Access Compliance Report

Public Rights-of-Way

(Curb Ramps)

Intersection ID: 43742	Main Street: RED_CLAY_LN	Cross Street: VANHOY_LN	Location: SW
ADA ID: 7DB242C1257E	Ramp Type: PerpDiag	Initial Pass/Fail: Fail	Overall Compliance: No
		Severity Score: 10

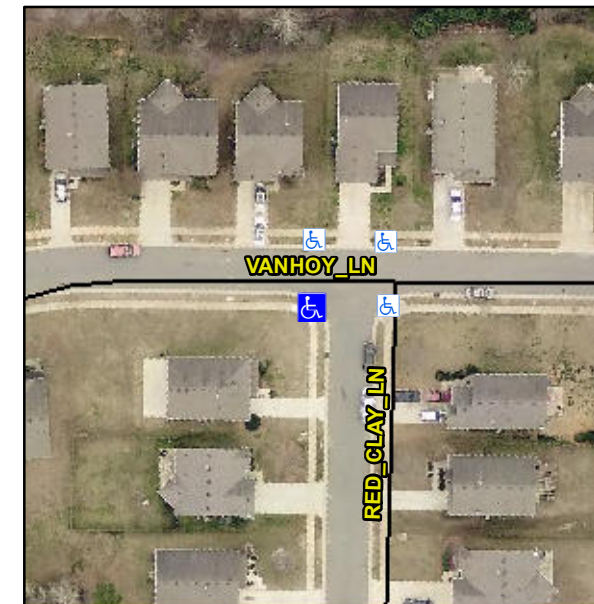
Not Found, R304.5.1, R304.5.3

Compliance	Description	Data	Compliance	Description	Data
N/A	Ramp Length (in)	49.0	Yes	Ramp Slope (%)	8.1
No	Ramp Width (in)	38.0	No	Ramp XSlope (%)	3.3
N/A	Flare Type LT	N/A	N/A	Flare Type RT	N/A
N/A	Flare Slope LT (%)	N/A	N/A	Flare Slope RT (%)	N/A
N/A	Flare Traversable LT?	N/A	N/A	Flare Traversable RT?	N/A
N/A	Landing Length (in)	N/A	N/A	DWS Provided?	N/A
N/A	Landing Width (in)	N/A	N/A	DWS Contrast?	N/A
N/A	Landing Slope (%)	N/A	N/A	DWS Length (in)	N/A
N/A	Landing X Slope (%)	N/A	N/A	DWS Full Width?	N/A
N/A	Landing Curb? (Y/N)	N/A	N/A	DWS Offset (in)	N/A
N/A	Shared Landing?	N/A			
N/A	Gutter Ponding?	N/A	N/A	Gutter Slope (%)	N/A
N/A	Gutter Lip Ht (in)	N/A	N/A	Gutter X Slope (%)	N/A
N/A	Painted X Walk1?	No	N/A	Painted X Walk2?	No
	X Walk 1 Direction	To E		X Walk 2 Direction	To N
N/A	X Walk 1 Width (in)	N/A	N/A	X Walk 2 Width (in)	N/A
	X Walk 1 Slope (%)	6.2		X Walk 2 Slope (%)	4.4
	X Walk 1 X Slope (%)	3.1		X Walk 2 X Slope (%)	6.3

Remove & Replace Curb Ramp With Two New Directional Ramps or Equivalent.
